STATE OF MAINE
DEPARTMENT OF TRANSPORTATION
16 STATE HOUSE STATION
AUGUSTA, MAINE 04333-0016

June 27, 2022
Subject: Matinicus Island Ferry Replacement
State WIN: 024897.10
Location: **Rockland**
Amendment No. 3

Wayfinder™

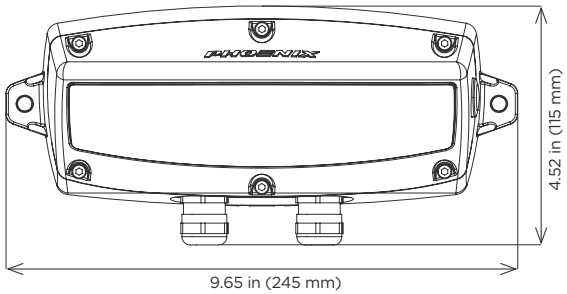
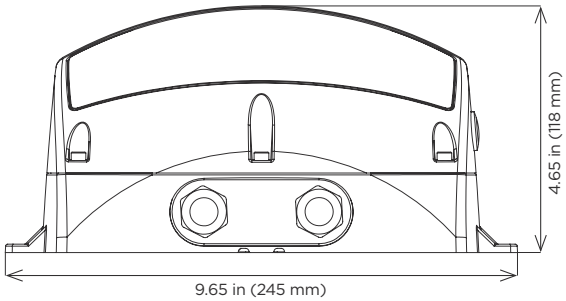
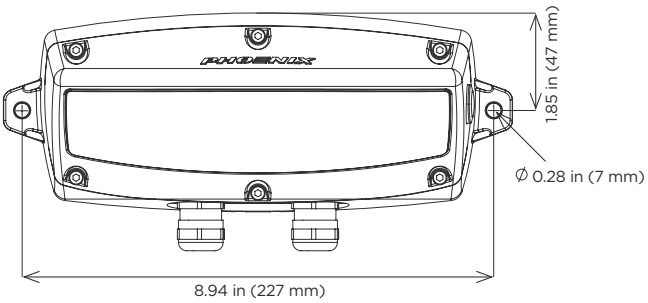
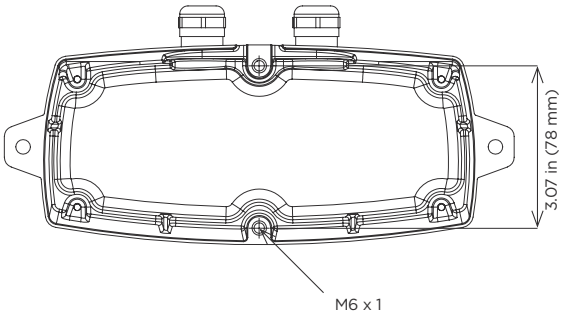
Question: On contract specification (D367-T8) page 52 & 53 in section 331.1 Railing & Bulwarks it calls out 32 each Eaton Vienza Marine Deck Lights Or equal. These lights are no longer available so is there a preferred light you would Like to use or do we need to submit an equal?

Response: We have confirmed that Eaton Vienza Marine Deck Light is no longer commercially available. Per 46 CFR 111.75-20 a substitute must be in compliance with the UL 1598A standard. Please use Phoenix Lighting Wayfinder LED Accessway light or Red Sky Lighting Round Series LED fixture as a substitute. The specific model shall be approved by the Resident and MSFS. The deck lighting shall not interfere with vehicles on the main deck. Please see the attached two documents for reference purposes only for Phoenix Lighting Wayfinder LED Accessway light, and Red Sky Lighting Round Series LED fixture.
